December 12, 2022

Re: Response to Additional Information Request for the Proposed Surrender and Decommissioning of the Newhalem Creek Hydroelectric Project (P-2705-037)

Seattle City Light (City Light) hereby responds to the Federal Energy Regulatory Commission's (FERC) Additional Information Request (AIR), issued on October 28, 2022, for the proposed license surrender and decommissioning of the Newhalem Creek Hydroelectric Project, FERC Project No. 2705 (Project). The decommissioning of FERC Project No. 2705, including all alternatives, will hereafter be referred to as "Decommissioning Project."

Figure 1. Longitudinal Profile of Newhalem Creek Upstream from Diversion Structure with Potential Profile Adjustments.

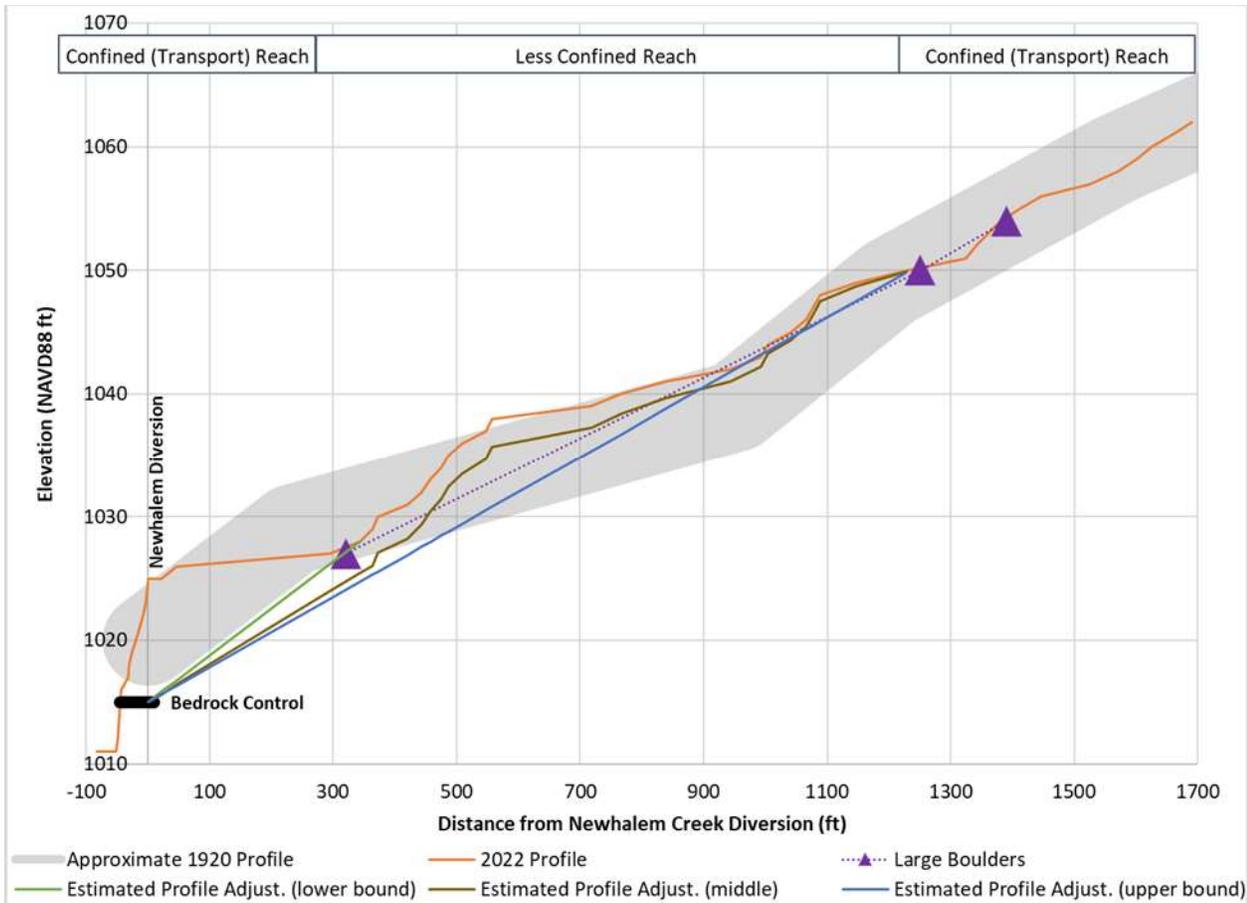
Three bounding estimates of the amount of potential channel lowering shown in Figure 1 were made based on the following assumptions:

- Lower bounding estimate: Assumes the 8- to 12-foot diameter boulders 320 feet upstream from the existing diversion will be a grade control; the channel downstream from this location would lower to the green line in Figure 1. This would correspond with a total volume of approximately 4,400 cubic yards of sediment being transported downstream.

- Middle bounding estimate: Assumes Newhalem Creek erodes into the right bank at the location of the 8- to 12-foot diameter boulders (320 feet upstream from the existing diversion) and there are smaller boulders in the new channel location that allow some downcutting at this location. The stream continues to adjust the profile, but instead of a straight line (like the upper bounding estimate described below), the stream adjusts to a new profile with a similar shape as the existing profile. The brown line in Figure 1 shows a hypothetical new profile using these assumptions. This would correspond with a total volume of approximately 9,000 cubic yards of sediment being transported downstream.

- Upper bounding estimate: Assumes the stream erodes toward the right bank and around the boulders at Station 320, there are no boulders in the right bank to form a grade control and the stream continues to adjust upstream to the location of the 5-foot angular boulders distributed across the stream 1,251 feet upstream from the diversion. In this scenario, the stream adjusts to a straight-line profile from the bedrock under the diversion structure to the boulders at station 1,251. This scenario also assumes these boulders will be a grade control, and the stream would lower to the profile shown as the blue line in Figure 1. This would correspond with a total volume of approximately 12,900 cubic yards of sediment being transported downstream.

Figure 2. Estimated Amount of Bed Lowering Upstream from Diversion Structure with Potential Profile Adjustments.

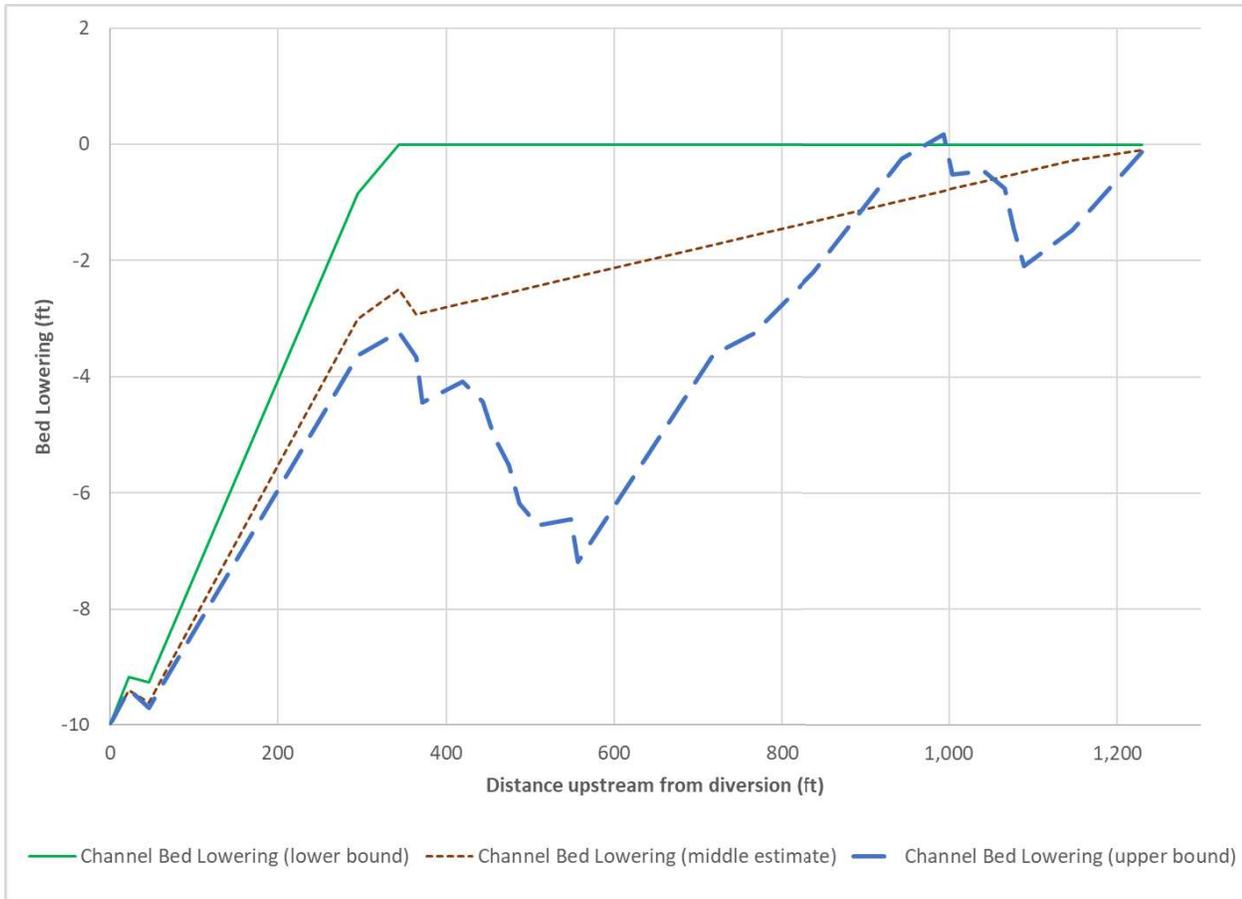
Change in channel bed elevation was determined by subtracting the 2022 bed elevation from the estimated lower, middle, and upper bounding profile lines. Bed lowering would be greatest just upstream from the removed diversion and at the top of the "steps" in the 2022 profile, with a maximum of 10 feet of bed lowering at the diversion structure (since that is the height of the dam) as shown on Figure 2. The estimated bed lowering would extend upstream, at varying depths, from the diversion dam for either 320 feet (lower estimate, green line in Figure 2) or 1,251 feet (middle and higher estimate, brown dotted and blue dashed lines, respectively in Figure 2).

In the short-term, immediately following diversion dam removal, the local stream gradient just upstream of the diversion would increase the sediment transport frequency. However, as the bed adjustment progresses upstream, the local gradient increase would become less until a new long-term bed profile is reached. As the local gradient increase becomes less, the corresponding energy to move particles becomes less, resulting in less frequent bedload movement and a slowing of the process. Channel bed adjustments can migrate upstream rapidly in fine-grained sediments, but the large particle sizes in Newhalem Creek will form an armor layer and further reduce the speed of channel adjustment. Additionally, the large, immobile boulders noted above will limit channel incision and channel adjustment progression. It is anticipated that as an armor layer forms, the larger substrate will be mobile much less frequently, and channel adjustments will take several decades. Over time, a new equilibrium channel gradient will develop.
